**The Philadelphia Parking Authority
701 Market Street, Suite 5400
Philadelphia, PA 19106**

**Bid No. 26-10
Trailer Plumbing Connections at Lot 10
Addendum Two**

Appendix A
Revised Sheet C-04

PHILADELPHIA PARKING AUTHORITY
 PROPOSED PPA LOT 10 - TRAILER PLUMBING CONNECTION
 6 E OREGON AVE
 MAP 45S08, PARCEL 68, OPA 88-5900440
 CITY AND COUNTY OF PHILADELPHIA, 39TH WARD
 COMMONWEALTH OF PENNSYLVANIA 19148

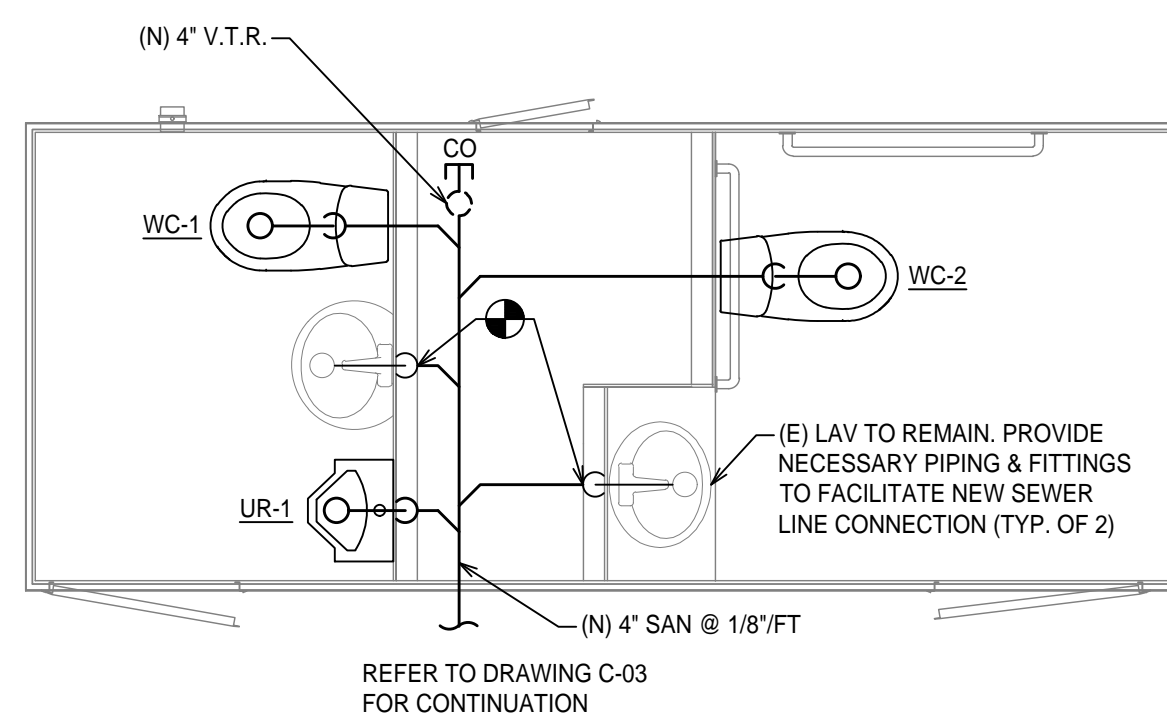
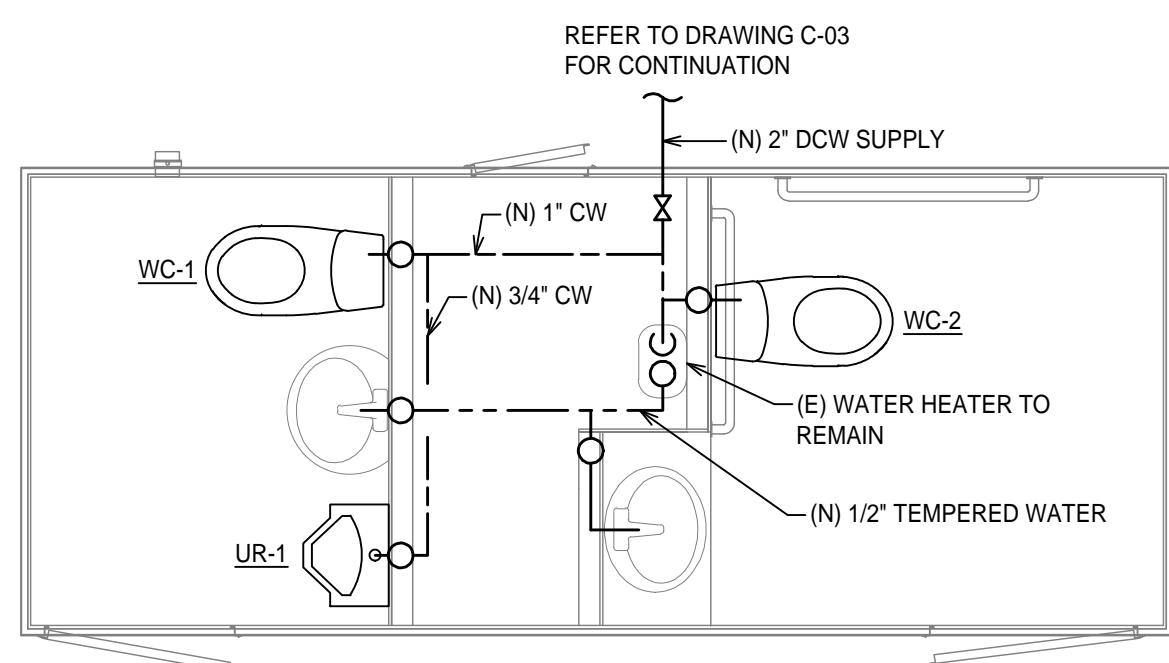
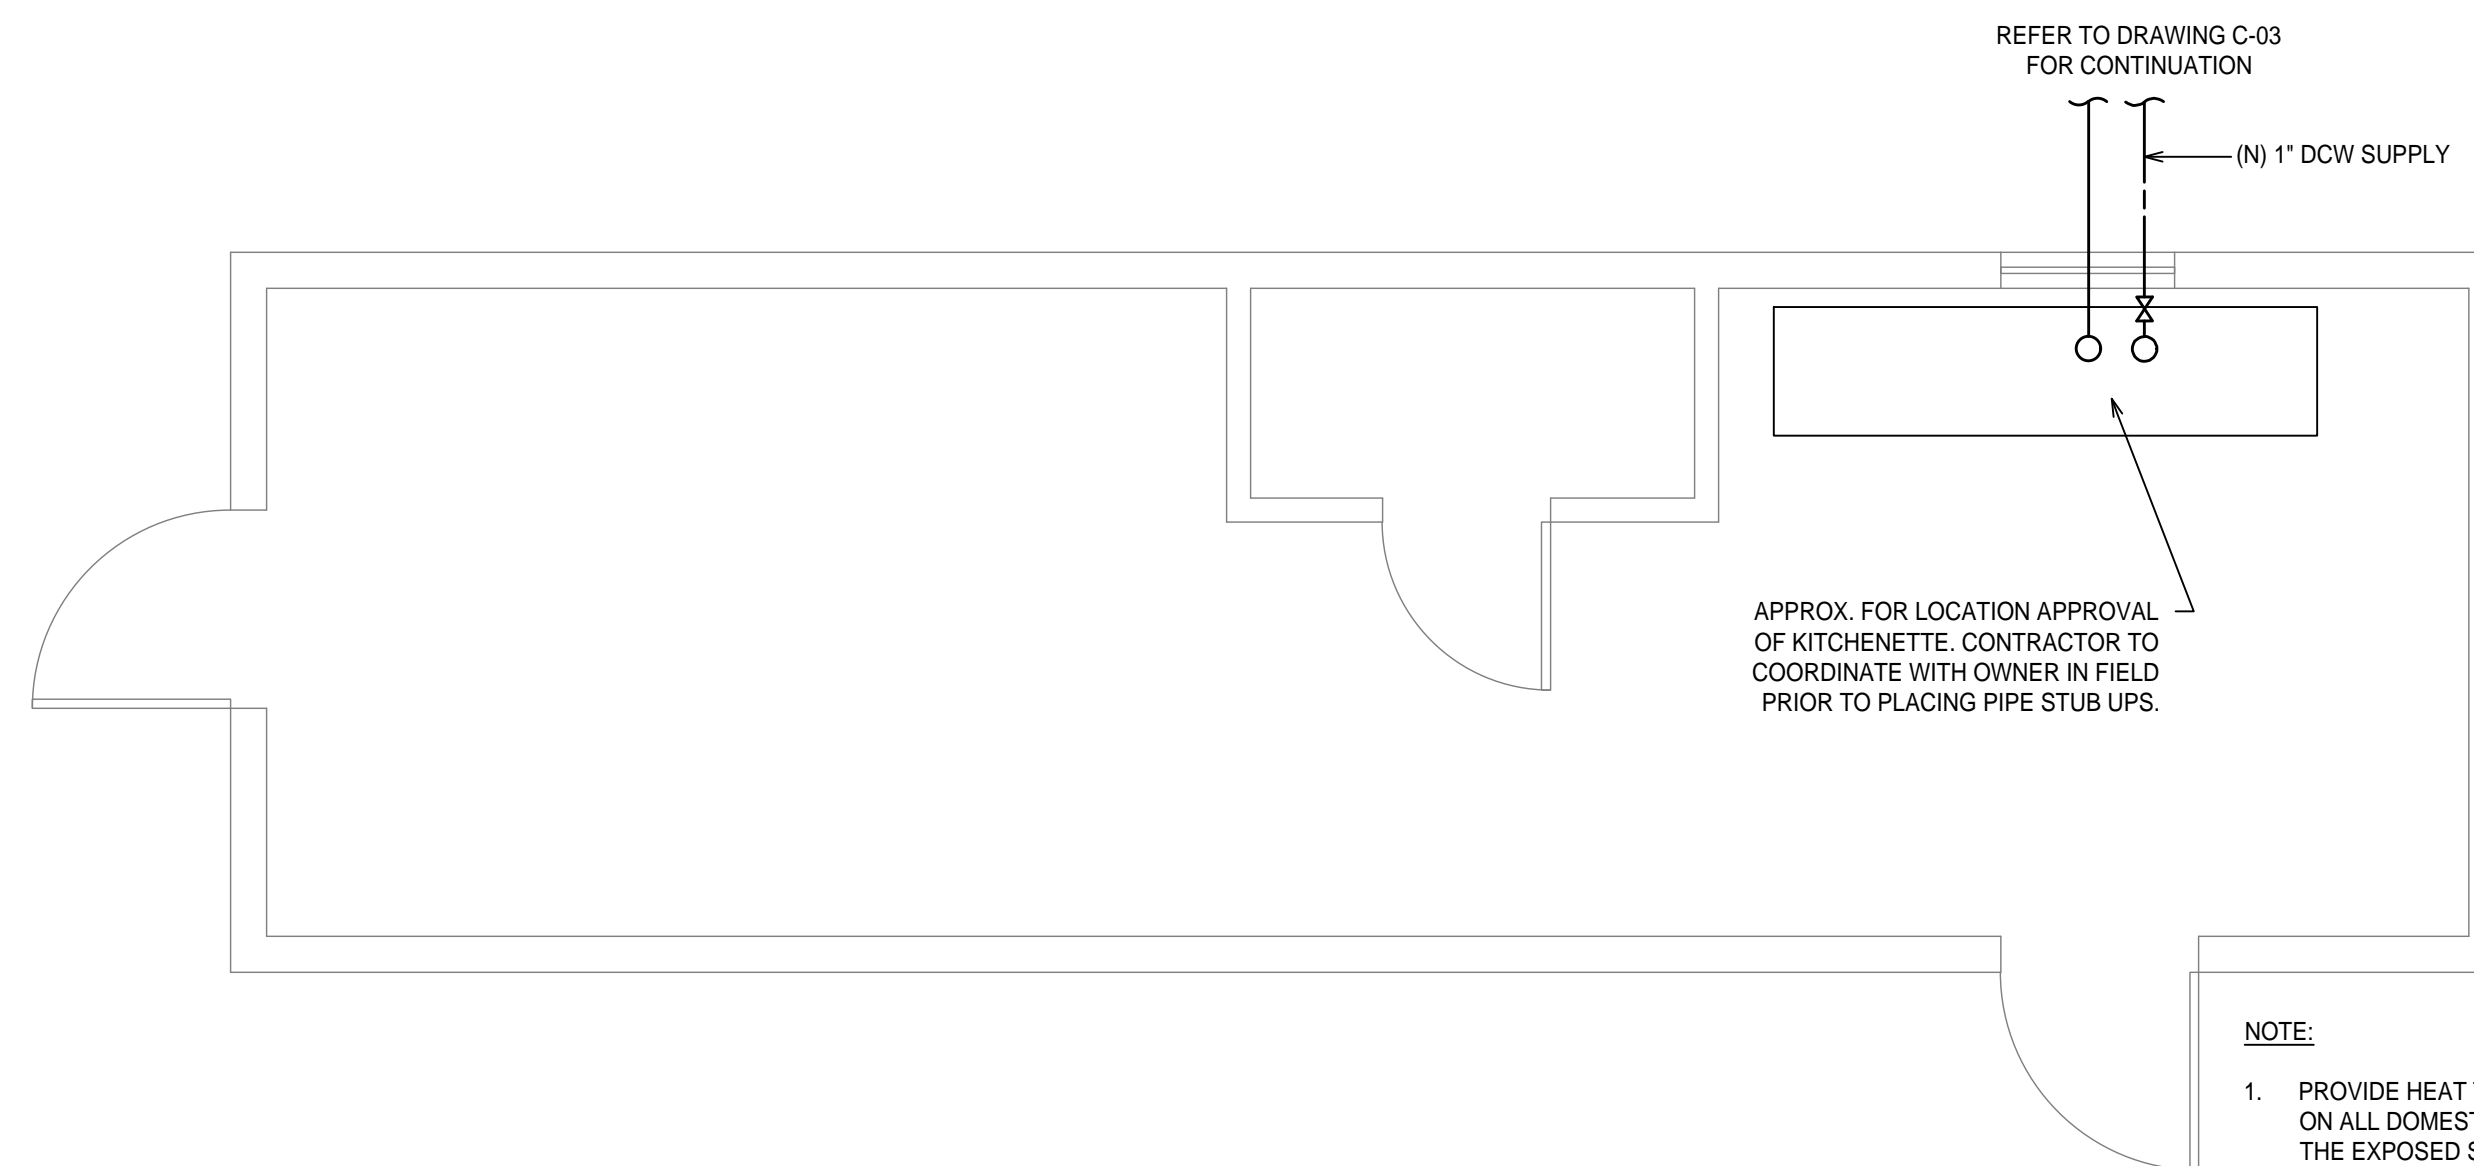
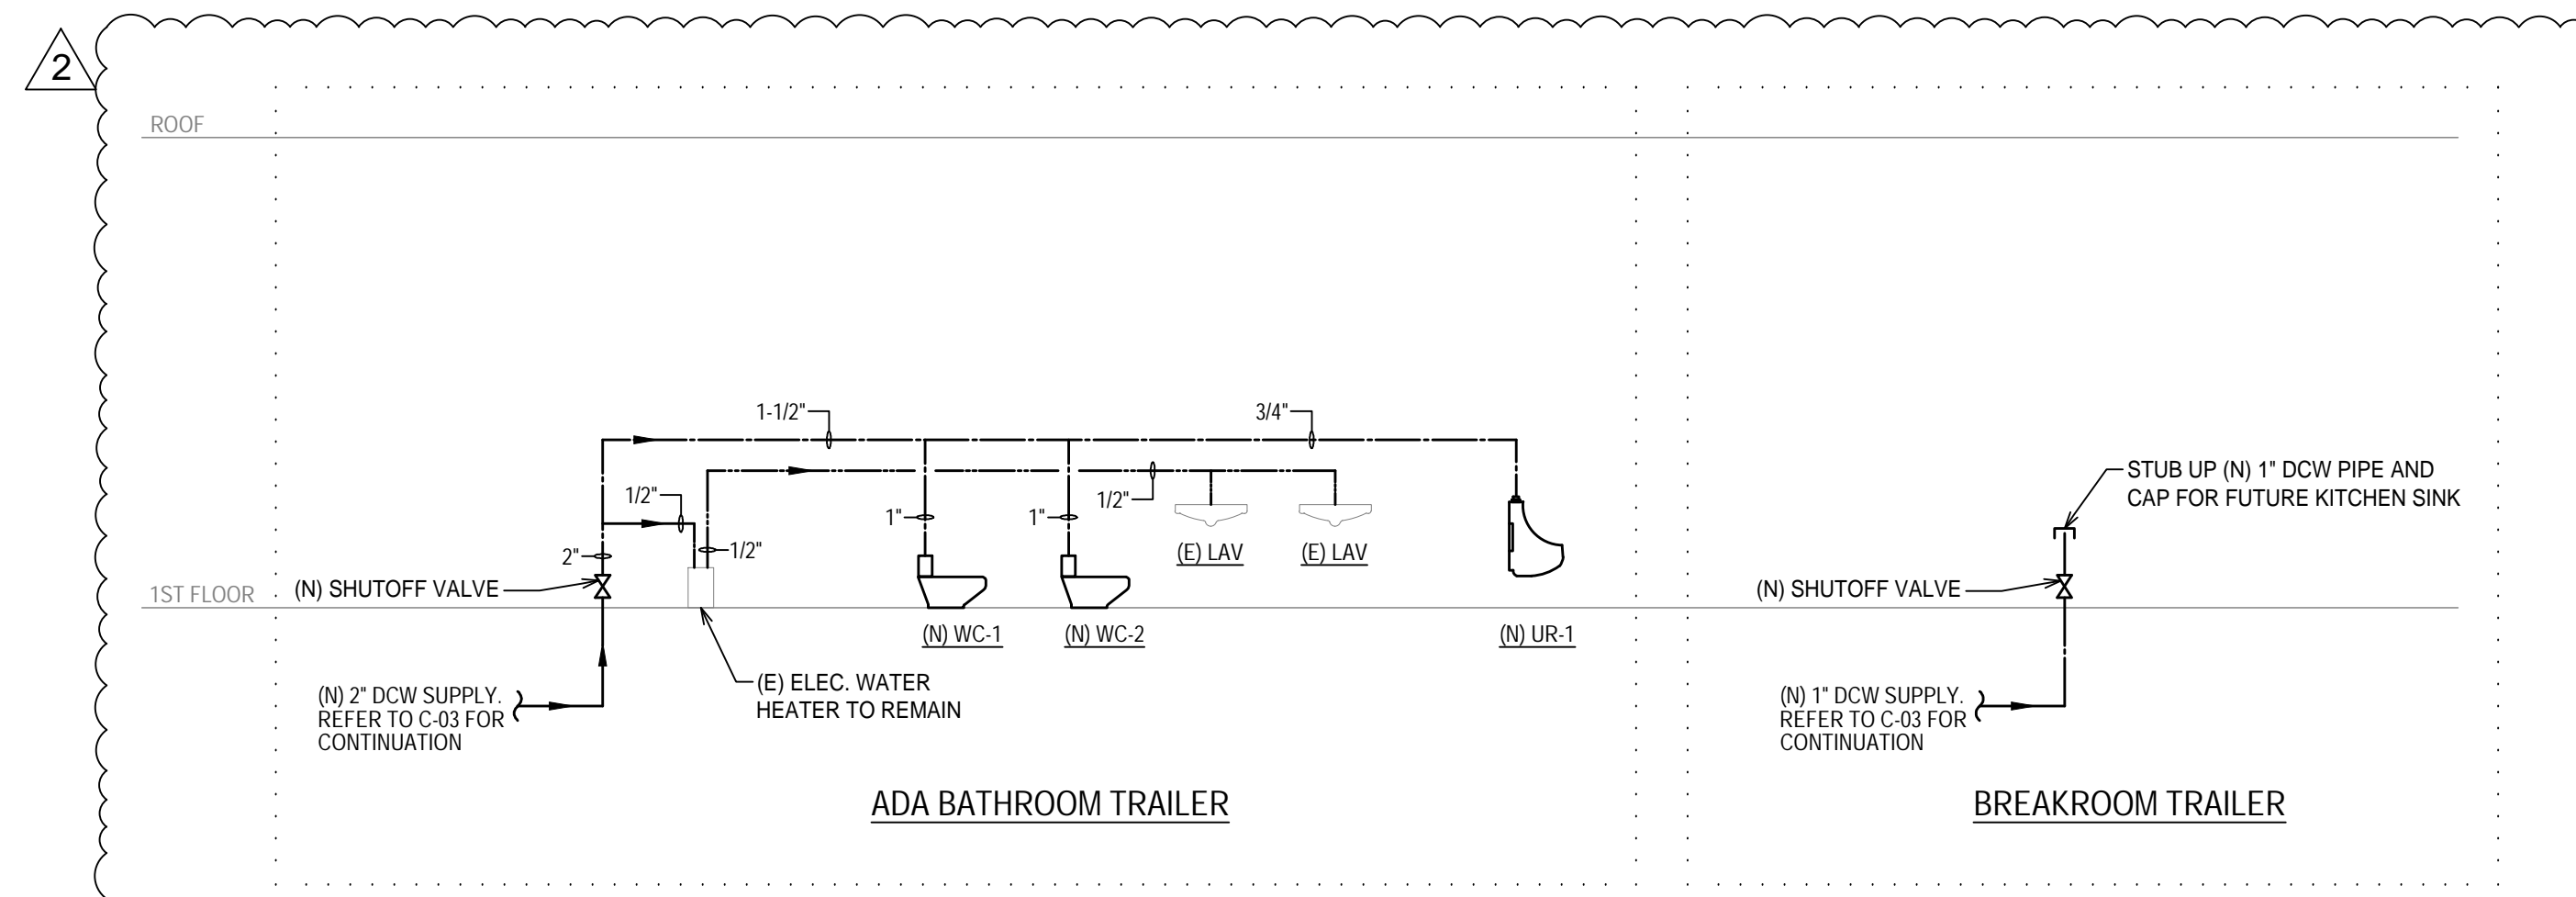
Response: Yes, cast iron service weight may be used for sanitary piping.
6. **Question:** Do we need to replace the existing inwall pex and pvc piping with metallic pipe or are we just connecting to the existing with new metallic pipe from underneath the trailer?

Response: Yes, the new proposed water closets and urinal are flushometer types, meaning the pipe diameter will need to be increased. Replace in-wall PEX and PVC piping with metallic piping as indicated in Appendix A of this Addendum.

2. **Question:** There is no plumbing material schedule shown on the drawings; materials are only shown on the civil drawings. Can a plumbing material schedule be provided?

Response: See Appendix A of this addendum for plumbing materials.
3. **Question:** Are we required to obtain a plumbing permit for the exterior plumbing and a separate permit for the trailer?

5 DOMESTIC WATER RISER DIAGRAM

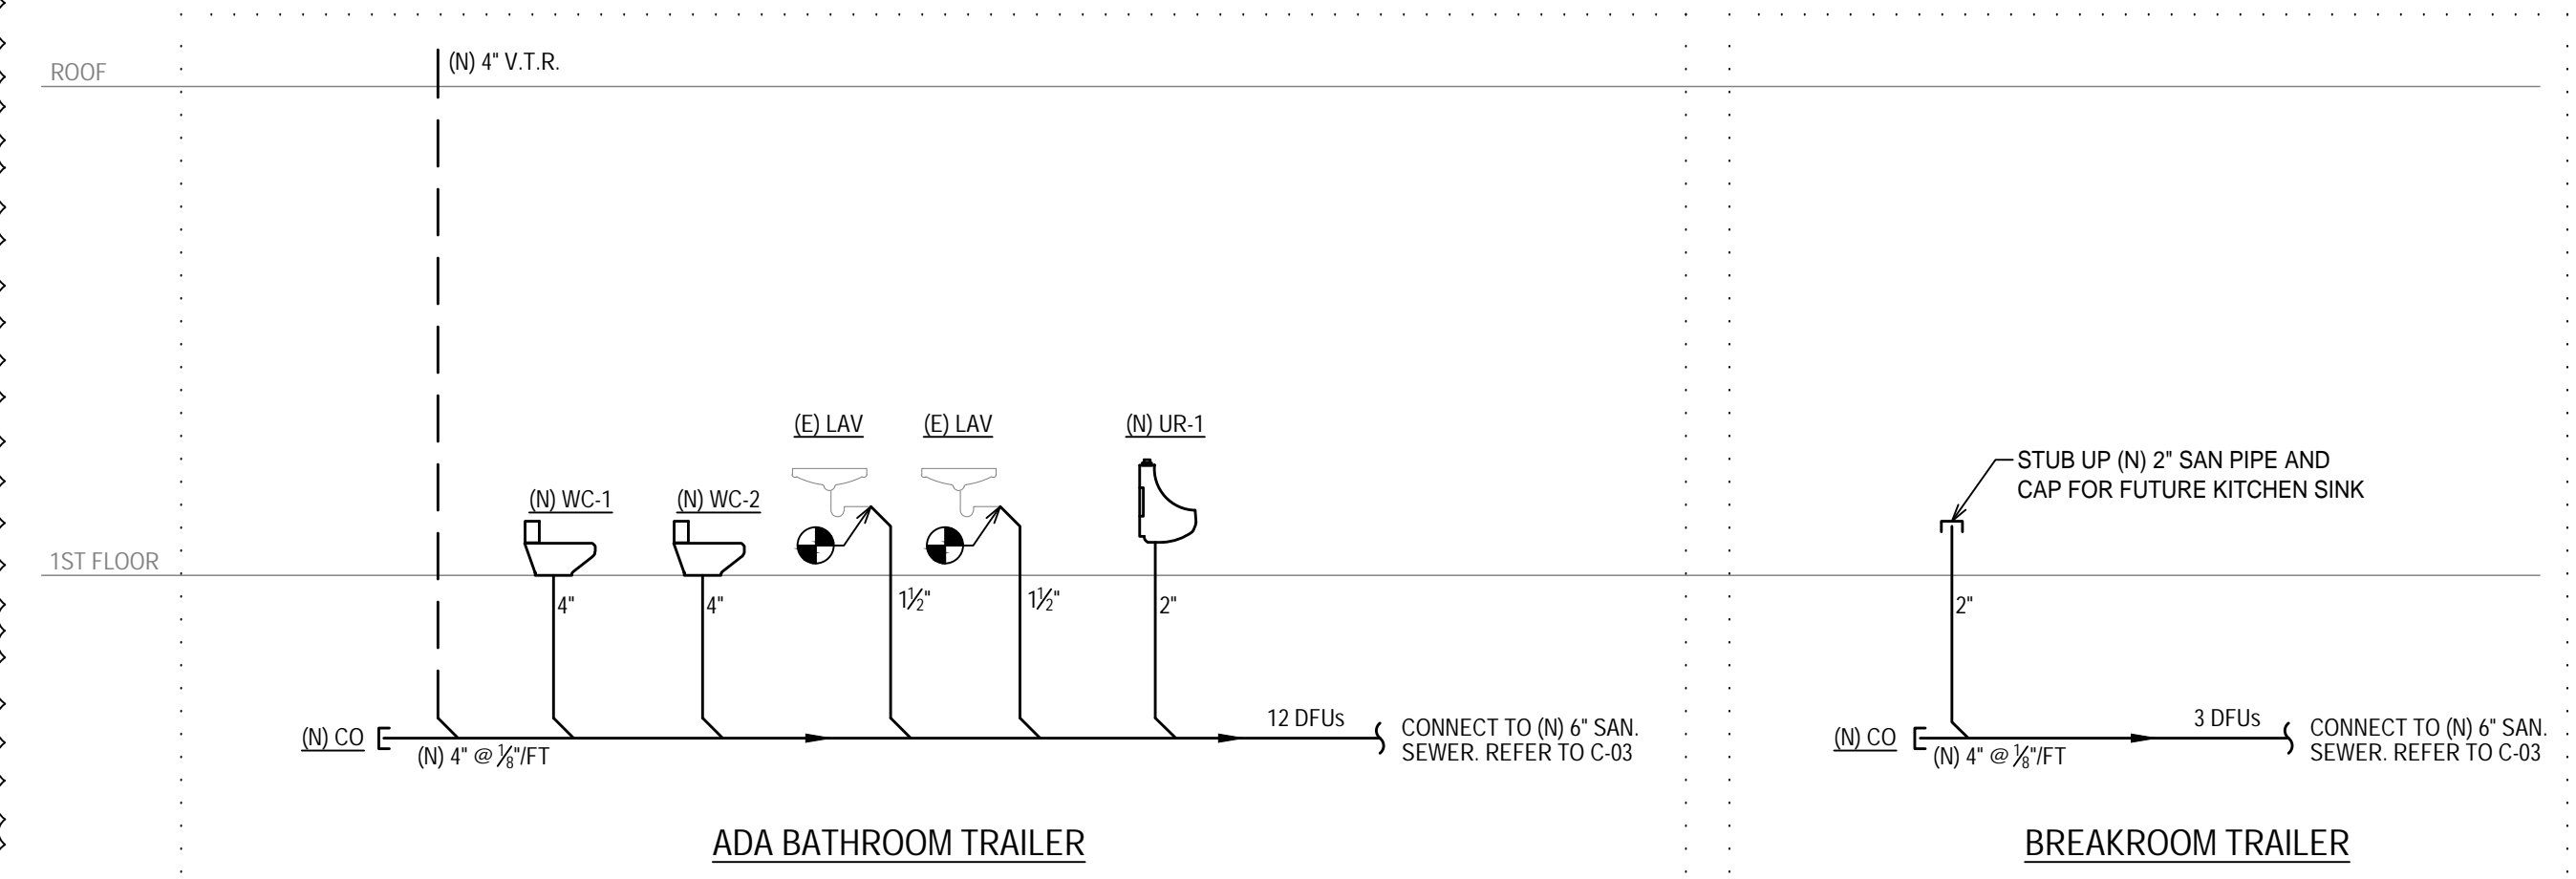
1. **Question:** There is no plumbing riser drawing shown on the drawings. Can this be provided?
Response: See Appendix A of this addendum for plumbing risers.

7. **Question:** Do we want to add another curb cock/ shut off valve for the existing bathroom trailer off the new main in the underground?

Response: Yes, new shut-off valves must be installed in both the bathroom trailer and the breakroom trailer. See the riser diagram of Appendix A of this Addendum.
